Revised Technical Specifications for  
Section 6 Administrative Controls  
Editorial Changes

Revised Pages: 220, 221, 222, 224, 225, 231, 236, 237

Figure 6.1.2  
NPPD Cooper Nuclear Station  
Organization Chart

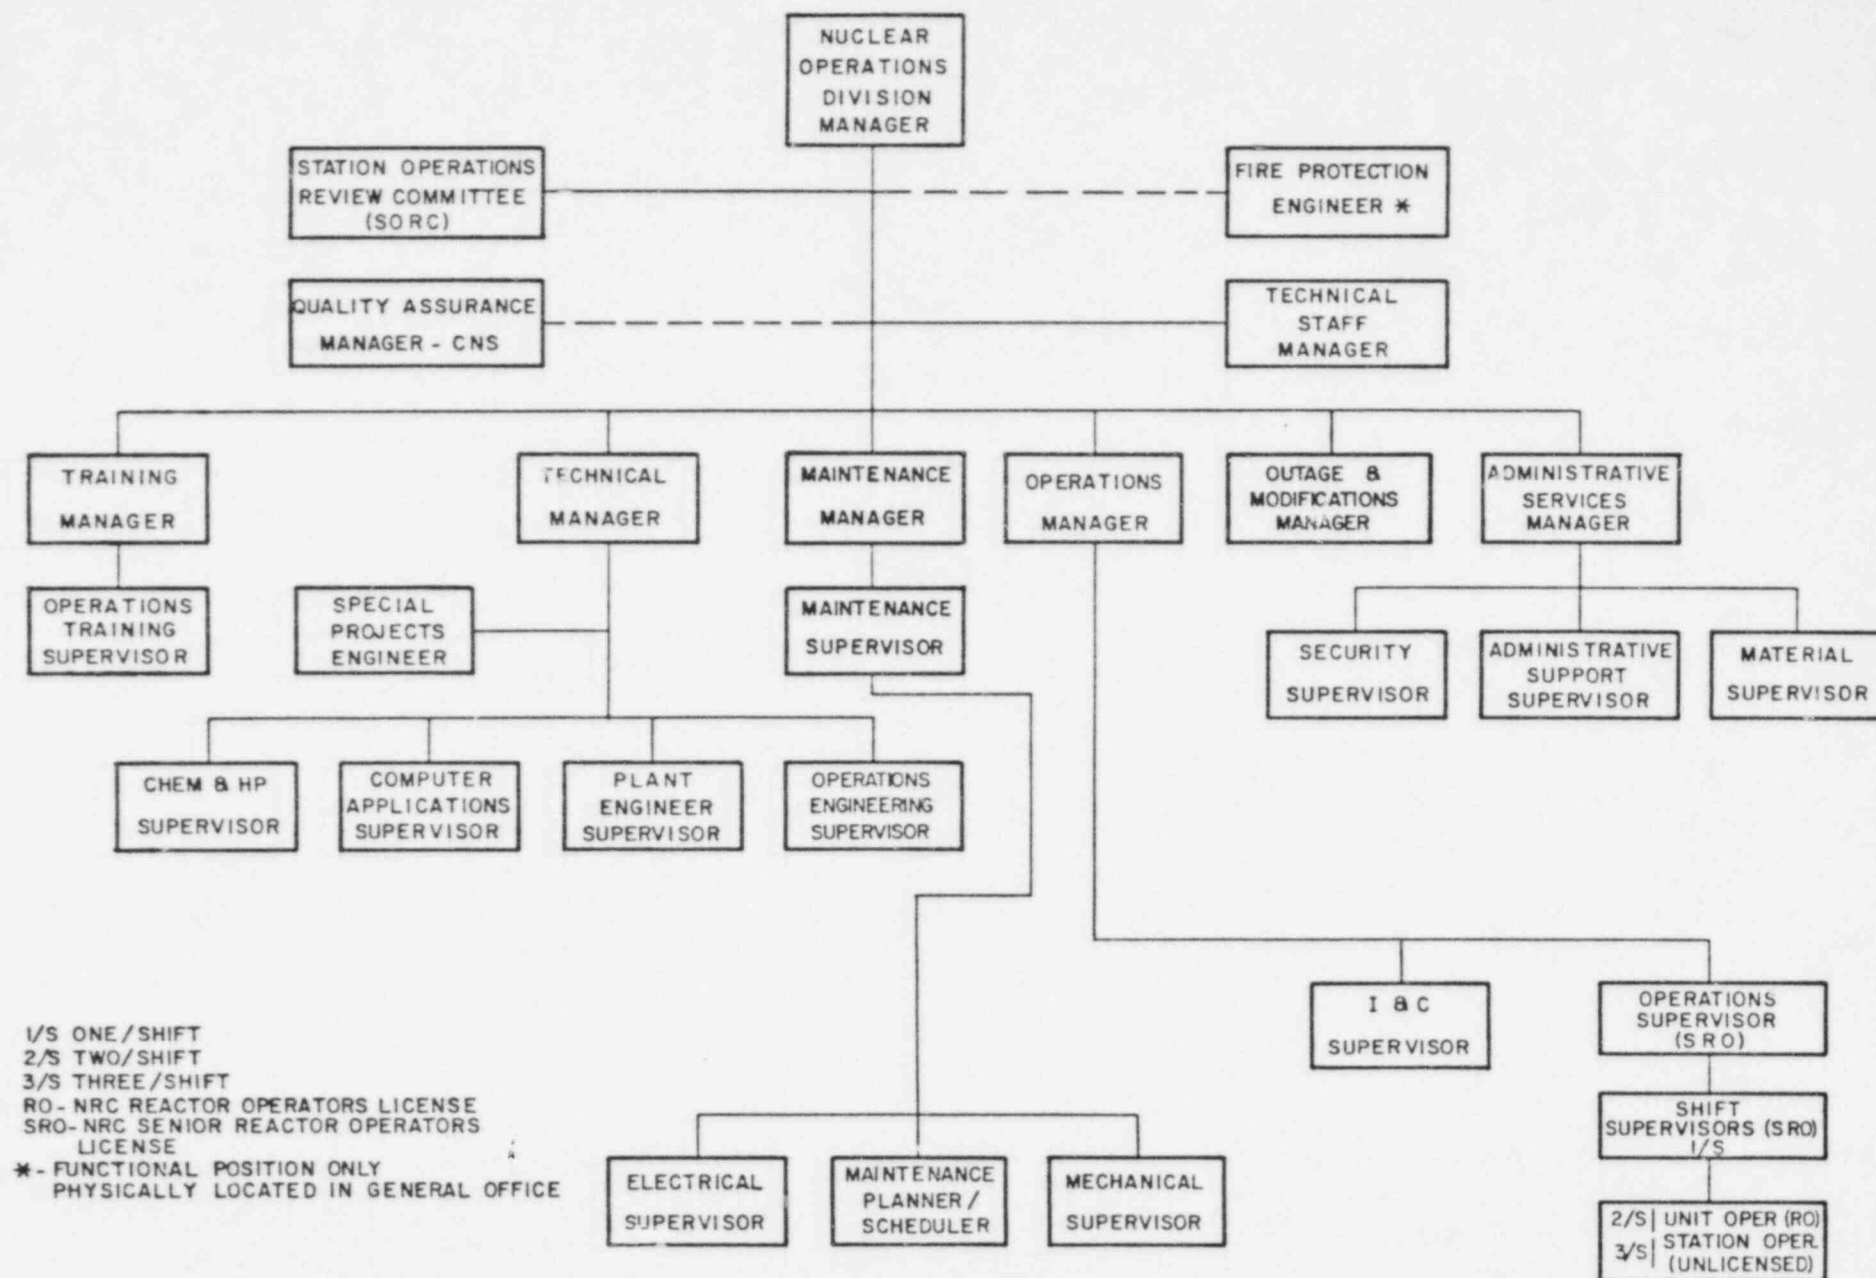
The District recently added two new management positions to its organization. These positions have been identified as the Maintenance Manager and the Outage & Modifications Manager. The Maintenance Manager will be in charge of the Maintenance Group (Electrical, Mechanical, Maintenance Scheduling). The Operations Manager used to fulfill these functions but his maintenance duties have been delegated to allow him more time in operations management. The Outage & Modifications Manager will be responsible for outage-related and design modification activities. The attached change shows the revision to the Organization Chart as a result of these new positions, and the Maintenance Managers addition to SORC. Additionally, the General Manager, Assistant General Manager - Nuclear, and Reactor Engineer Supervisor have had their titles changed to President, Vice President - Nuclear, and Operations Engineering Supervisor respectively. These changes are changes in title only and do not alter these individuals duties, or responsibilities, or cause a change in CNS's present organizational structure.
